TITLE: Sheet_1		REV: 1.0
EasyEDA	Company: Your Company	Sheet: 1/1
	Date: 2022-06-25	Drawn By: bramfeld

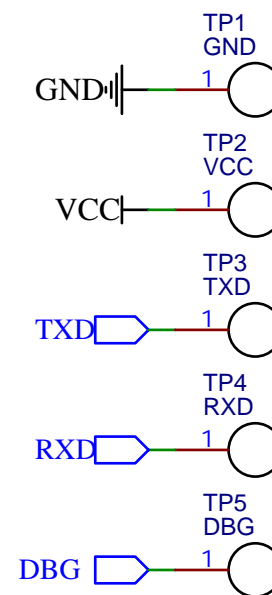
Errata:
 - D1-D4 circuit didn't work as intended
 - Buttons are too close to the edge, might get pressed by accident
